1740 NW MARKET STREET

2 DESIGN RESPONSE TO EDG

EDG PRIORITIES AND GUIDANCE

DEVELOPED MASSING

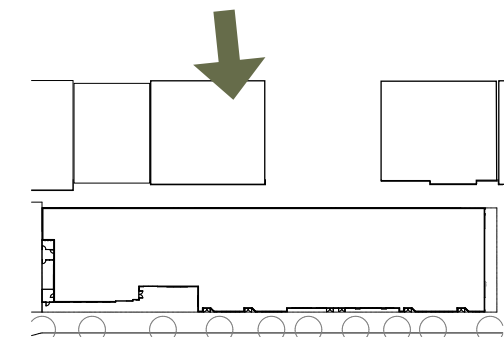
a. The Board unanimously supported the applicant's preferred massing scheme (Option 3) stating that it meets design guidelines and enhances street level experience.

b. Concerns were raised by Board members about the design's impact on neighboring buildings, but after discussion the Board stated that the massing of the preferred scheme would mitigate its great length by breaking it up into a series of differently scaled elements, with the west end appearing almost as a separate entity.

a. The preferred massing scheme, which was supported during Early Design Guidance, has been maintained and is now being presented as a fully developed building design to the Recommendation Board. Its development from EDG to Rec has been guided by the Board's priorities, as identified in this summary.

b. The overall massing composition of discreet yet interwoven light, dark and green masses has been strengthened so that the texture and color of each of these parts reinforces their massing delineation in breaking down the scale of the overall building.

NORTH ELEVATION

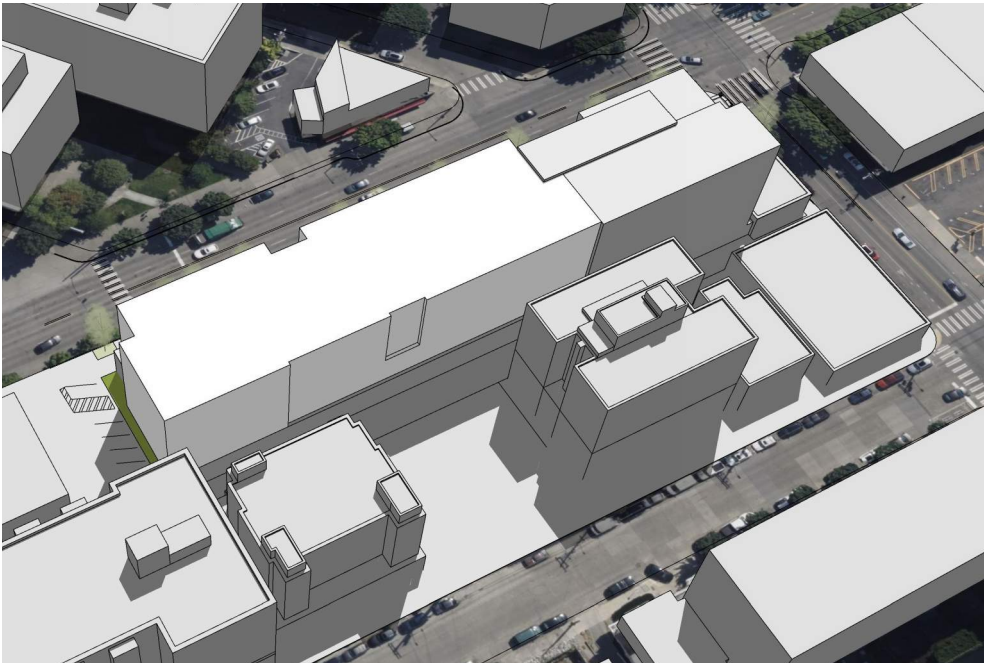
1. Massing Options
c. Echoing public comment, the Board also noted the potential for privacy issues at the north elevation and asked the applicant to address this concern as the design develops.

Response
The EDG board appreciated the generous massing setbacks from the priority Pedestrian Market Street frontage and to accomplish this, more of the massing was shifted towards the alley at the north.

It was also noted that the North façade would maintain the full 20' alley width up through all levels (not just for the lower two levels, as required for the alley dedication), which was seen as a positive for the neighbors across the alley. The project is also not utilizing the full building height allowable by land use code, which would have allowed for an additional floor.

The overall composition of dark and light colors has been reinforced through the material selection: Dark window frames in the dark wall, Dark Integrally-colored cmu at the ground level meeting the alley and then offset by a white portion of the façade. These different color zones of the façade help break down its apparent scale.

The white portion of the façade is what mostly fronts the two 7-story apartments across the alley, providing more reflected daylight into their windows.

GROUND LEVEL MATERIALS & DETAILS

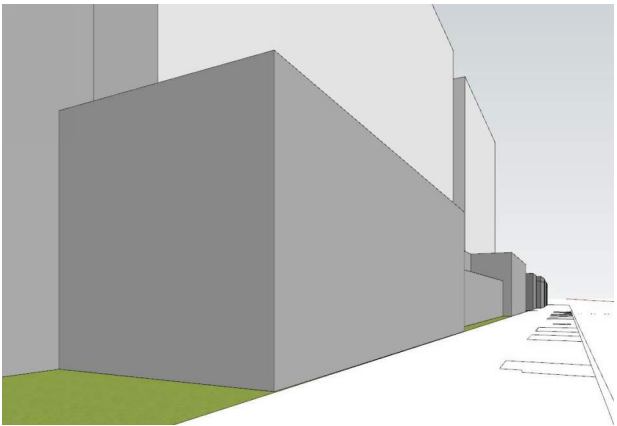
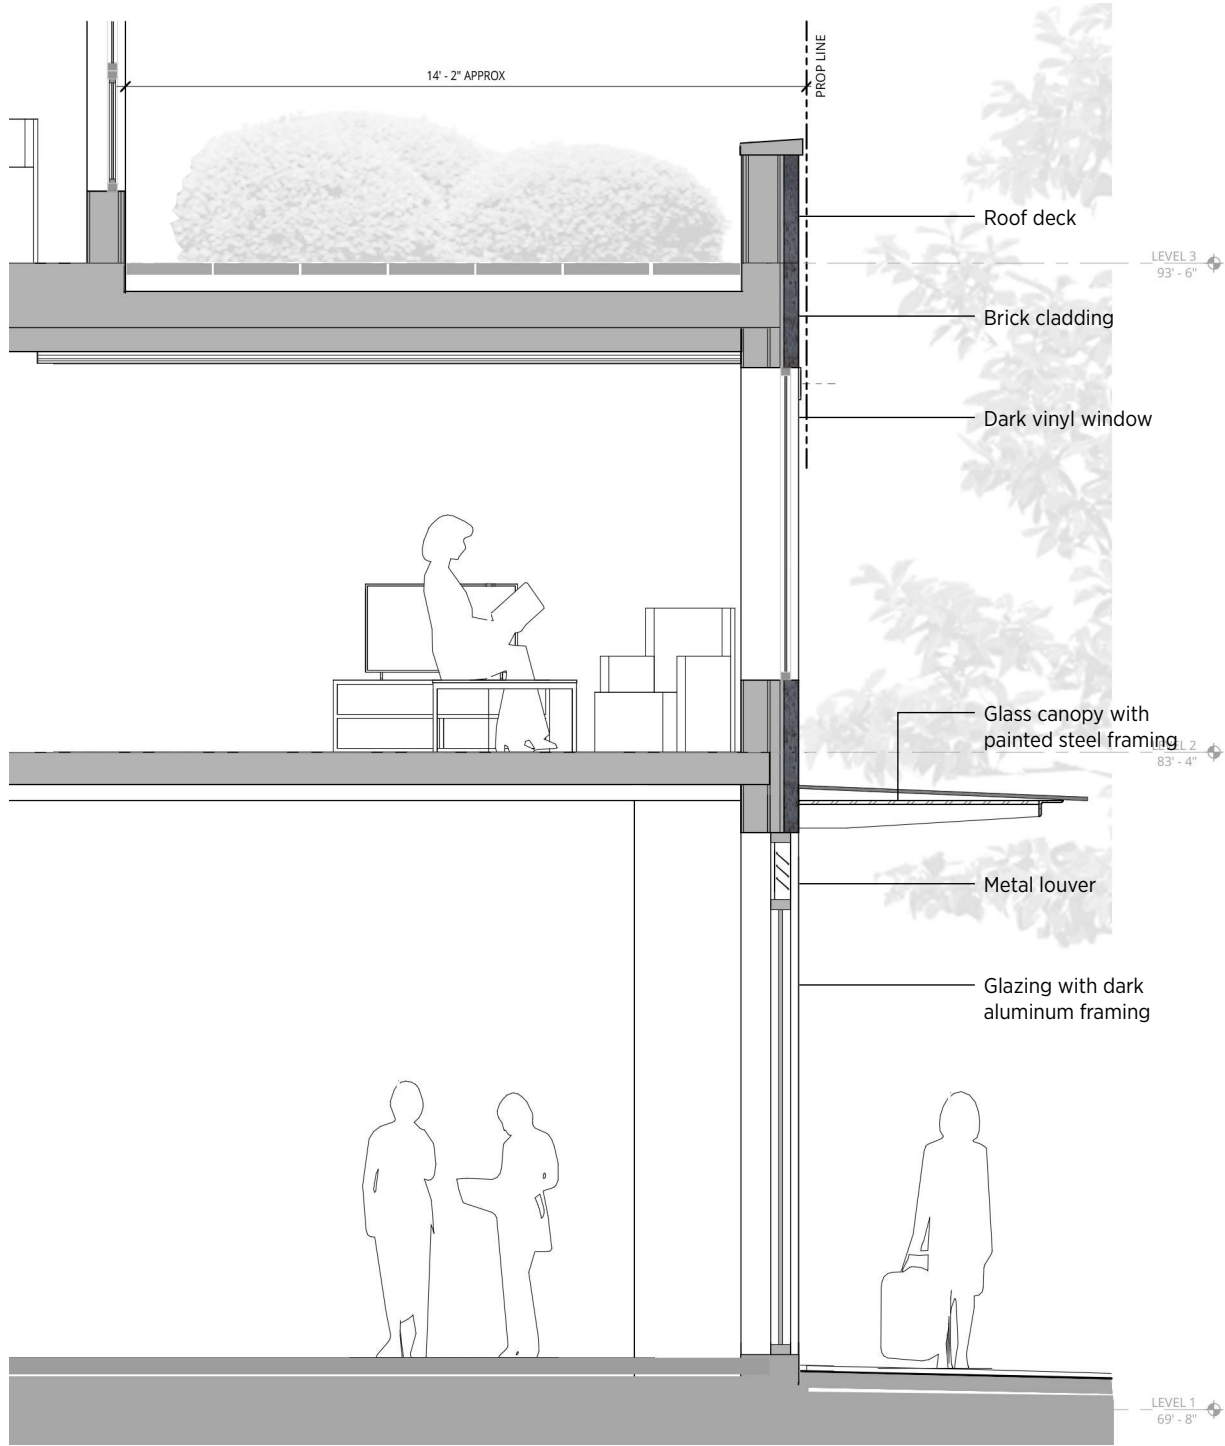
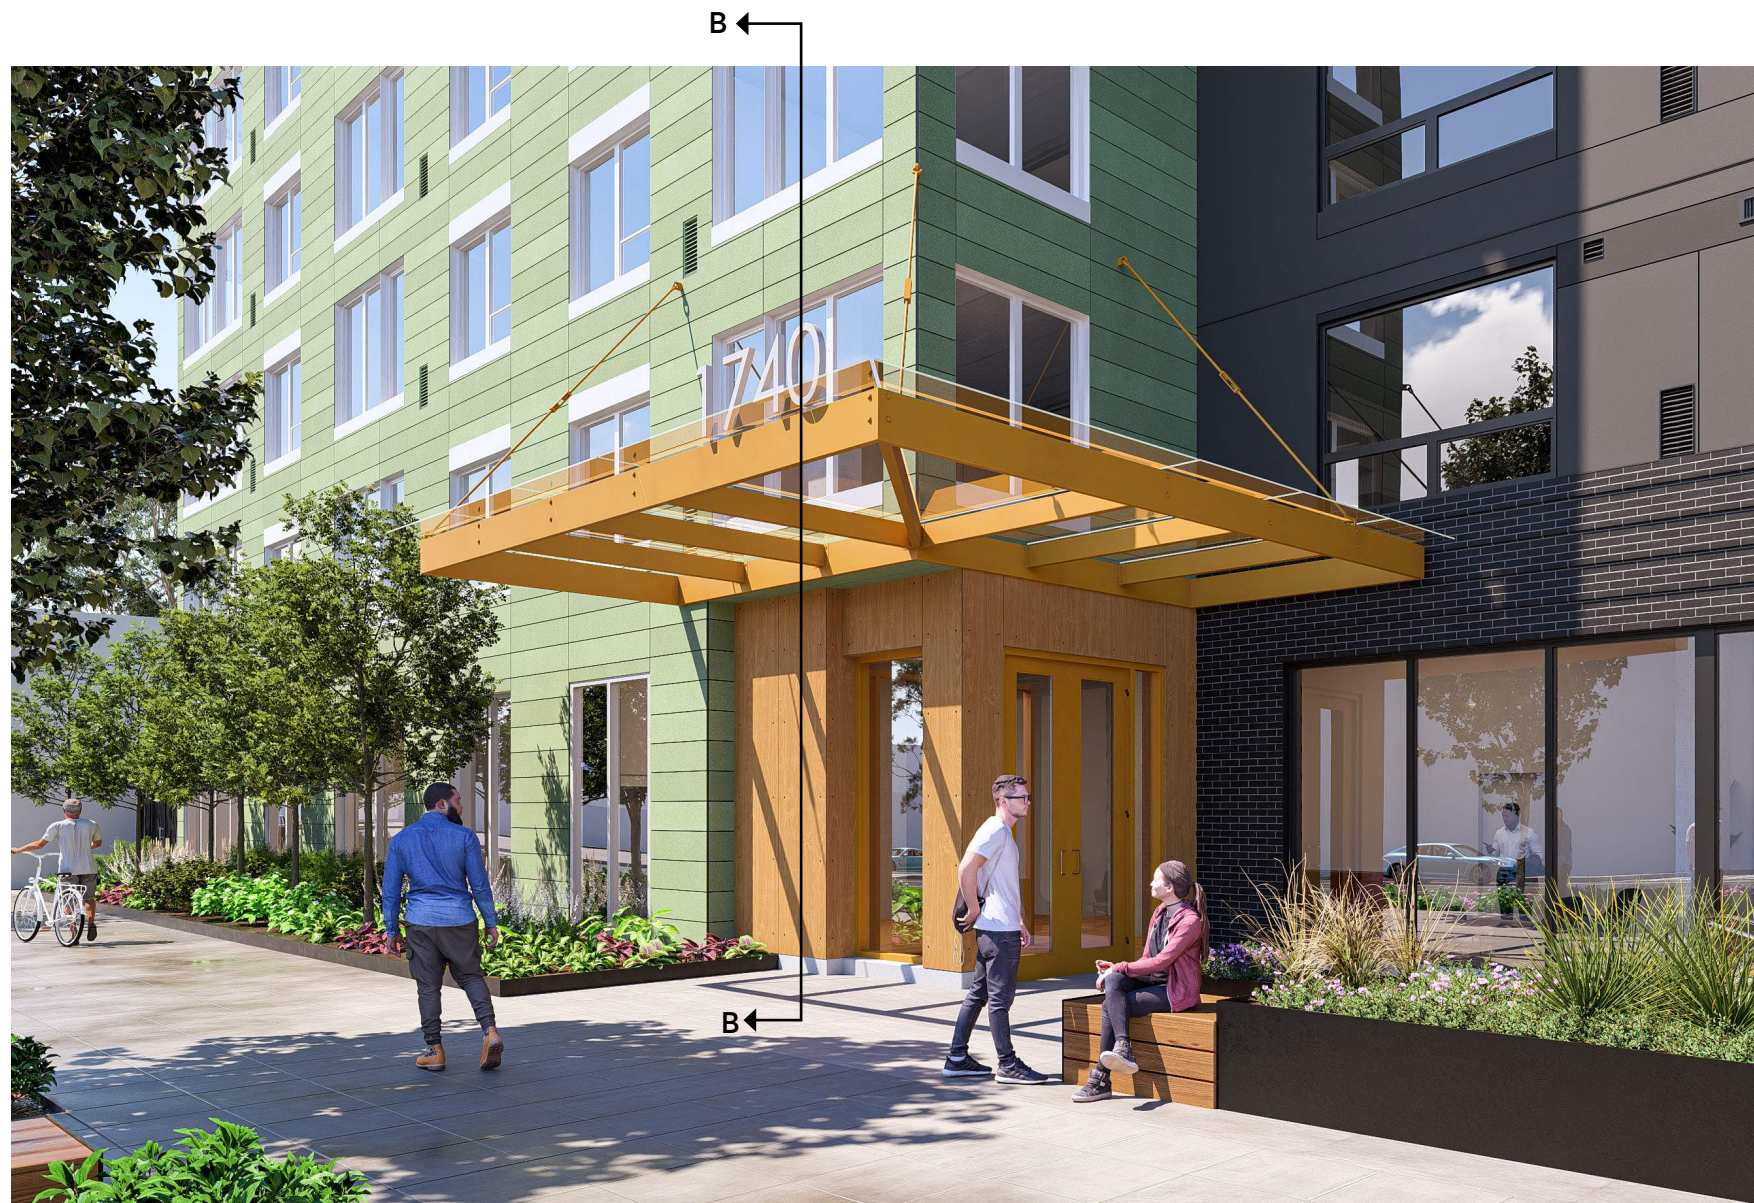
a. The Board stated that the continuous two-story expression at the street edge fit well with existing context and that combined with the fine-grained texture at the street edge helped bridge the difference between the smaller scale structures in the Ballard Neighborhood character core to the west and the newer larger scale buildings to the east.

The two-story base expression has been maintained and refined. This retail base is clad in a dark brick, imparting a feeling of permanence and human-scale (the texture of individual bricks assembled by hand). The base has also been subdivided into 3 sections along its length to better match the dimensions of Ballard infill buildings, with each section given subtly different massing and brick treatments. A continuous steel and glass canopy will allow light to reach the sidewalk while providing rain protection for pedestrians.

GROUND LEVEL MATERIALS & DETAILS

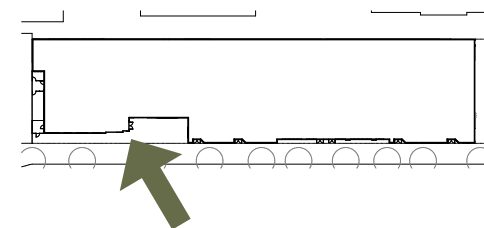
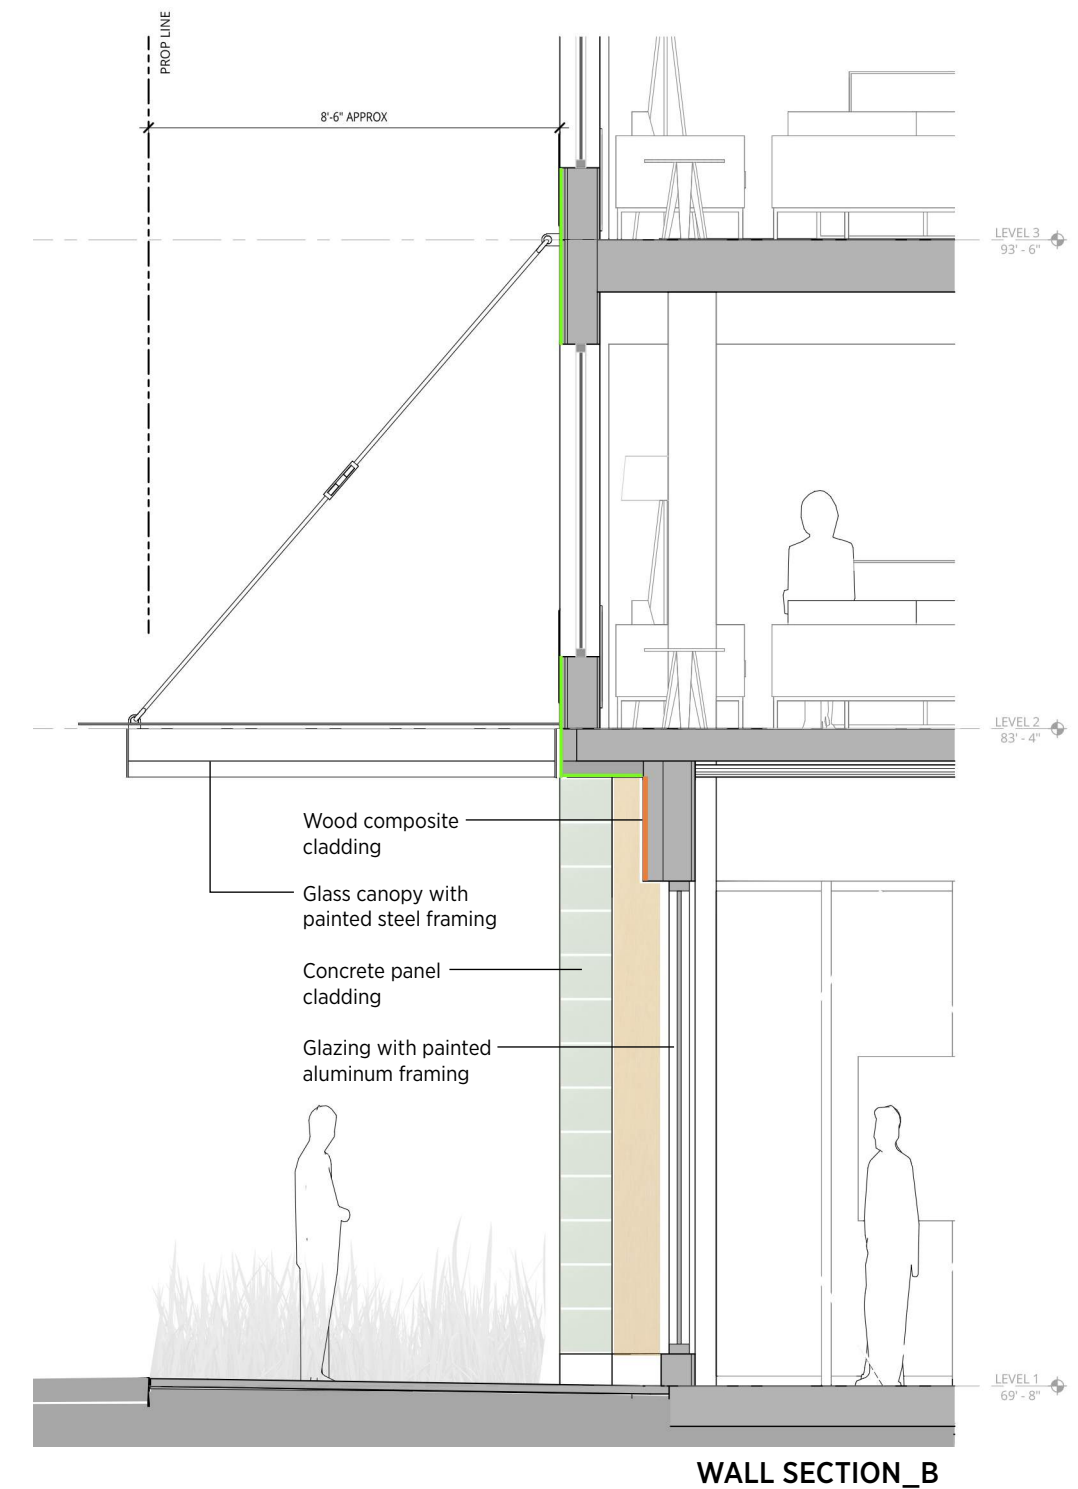
b. The Board noted the additional level of detail provided in the Early Design Guidance (EDG) packet indicated the intended character of exterior materials and detailing and agreed that they strengthened the scale-mitigation strategy of the design scheme.

The building details at recommendation are focused on making each massing piece read clearly on its own, which reinforces the overall scale mitigation concept and also on further sub-dividing each wall surface into smaller scale components that appear well-organized and interesting.

STREET LEVEL DESIGN

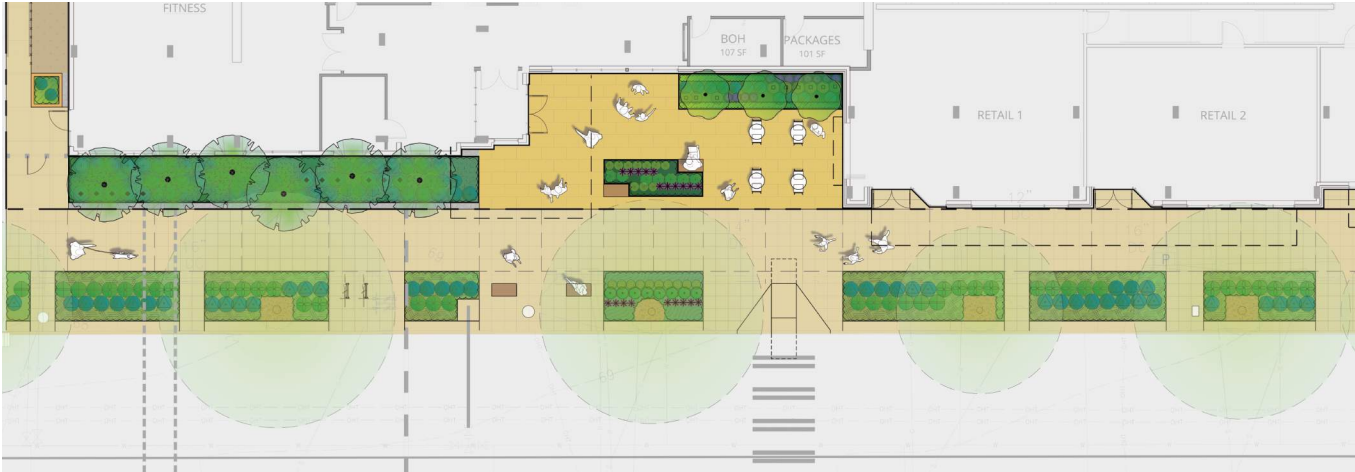
2. Massing and Modulation
c. The Board noted their particular support for the location of the entry courtyard along the street edge as a response to the diagonal intersection with Tallman Ave NW and connected to the new pedestrian crosswalk.

Response
The location of the entry courtyard has been maintained from EDG. It will be visible from across Market street and is identifiable as the focal point of the building, where the building's unique massing elements and maximum modulation intersect.

VIEW OF ENTRY PLAZA AT EDG

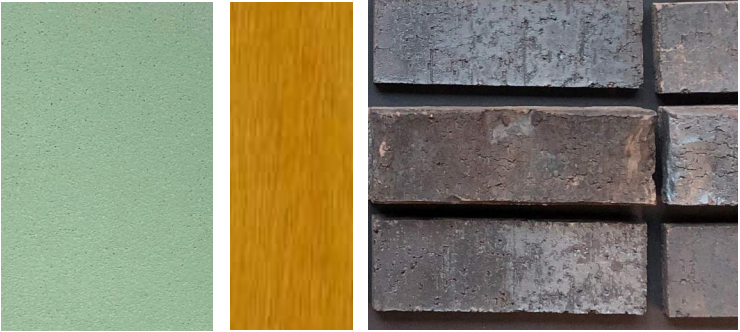
3. Street Level Design
a. The Board stated that the additional setbacks at the street level, particularly where retail spillover could occur at the entry courtyard, and the high-quality materials used at the street edge would contribute to a vibrant pedestrian environment and potential for engagement with the neighborhood.

Response
The entry courtyard has been maintained and enhanced since EDG. It is envisioned as a mix of sunlight and landscape, activated by both residents on the west and retail spill out on the east. The materials surrounding the plaza meet the design guidelines envisioned for the Character Core: Brick on the East and North and high-quality cementitious panel and wood-look composite panel on the West.

STREET LEVEL DESIGN

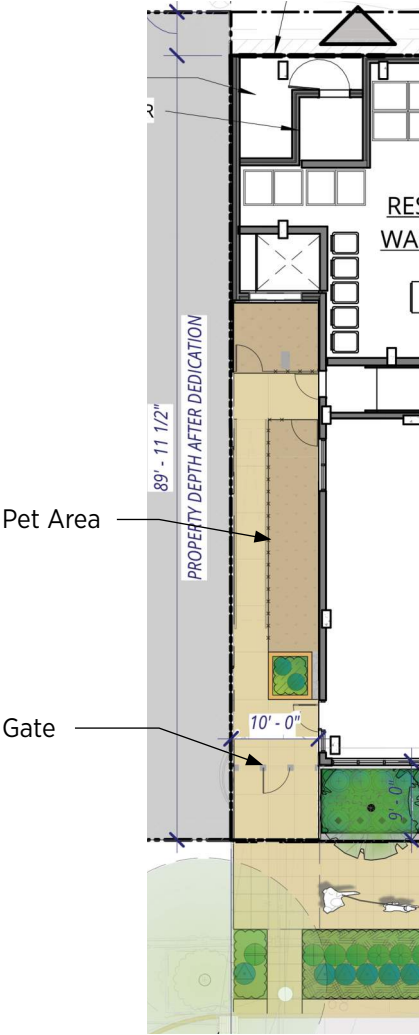
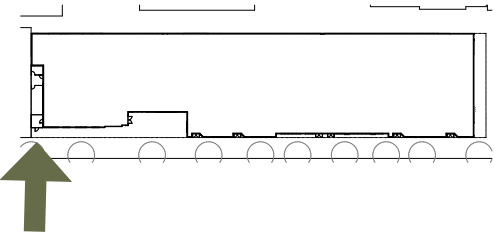
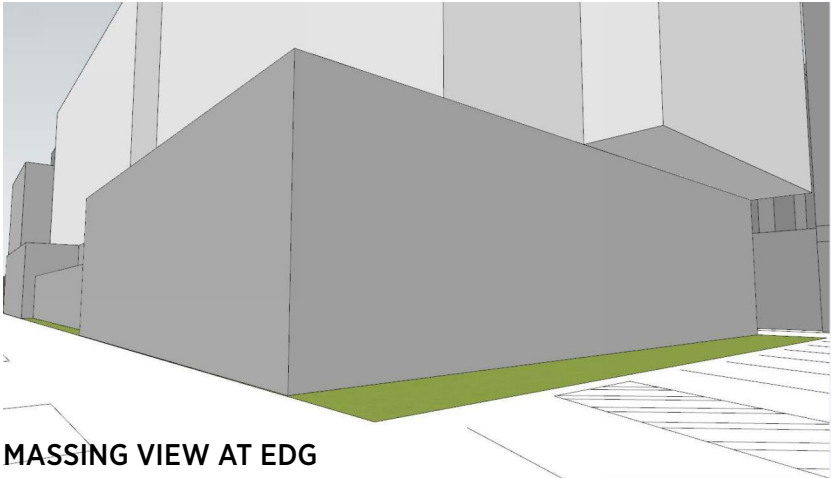
3. Street Level Design
b. The Board noted a potential issue at the west property line where the location of the existing structure abutting the entry courtyard could create a blind corner for pedestrians and asked the applicant to consider this as the design develops.

Response
The green portion of the new building is set back from the property line (and the existing building) 9' as a scale-reducing measure and to give extra light to the sidewalk. This 9' zone will be planted like a garden with large window into a residential lobby beyond. A 10' gap on the sideyard between the existing building and the new building provides a respectful buffer to the scale of this small corner building and this gap will be frequently used by residents as a pet area. Residents will be able to enter this gap through a perforated metal gate, sealing off the space to visitors and maintain the street edge for safety and visibility.

VIEW OF ALLEY CONNECTION AT RECOMMENDATION

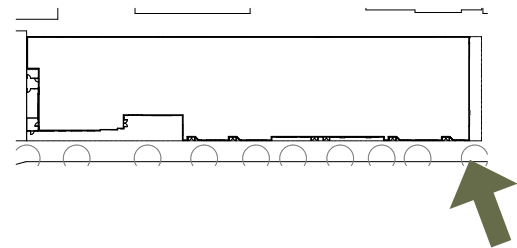
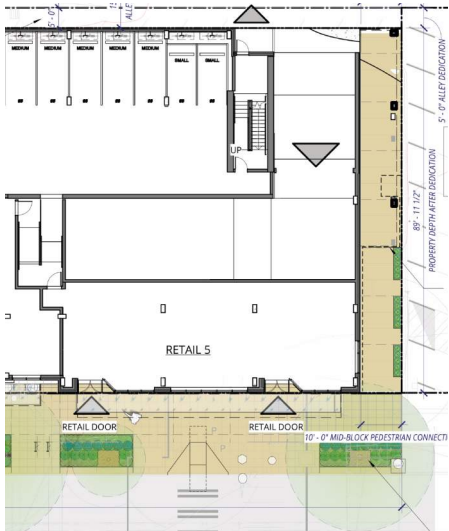
3. Street Level Design
c. The Board enthusiastically supported the street level connection between NW Market St and the alley to the north, noting its benefit as a connector on this long block to both pedestrians and cyclists and the additional relief and potential for activity it would add to the street edge.
d. The Board supported the retail programming at the street edge that included a high glazing percentage and multiple points of entry.

Response
c. This connection from Market Street to the alley has been maintained. Similar to the gap at the west, the lower level building façade at the east is voluntarily pulled back 10' from the property line but here the setback extends all the way through to the alley and the public is invited to traverse and connect to the alley at this mid-block location. The two story wall will be full height textured brick with patterning that recalls the spirit of Ballard. The upper levels of the residences extend overhead, supported by concrete columns. Lighting and landscaping will ensure visibility.
d. This retail programming at the street edge has been maintained and the small retailers will active the street.
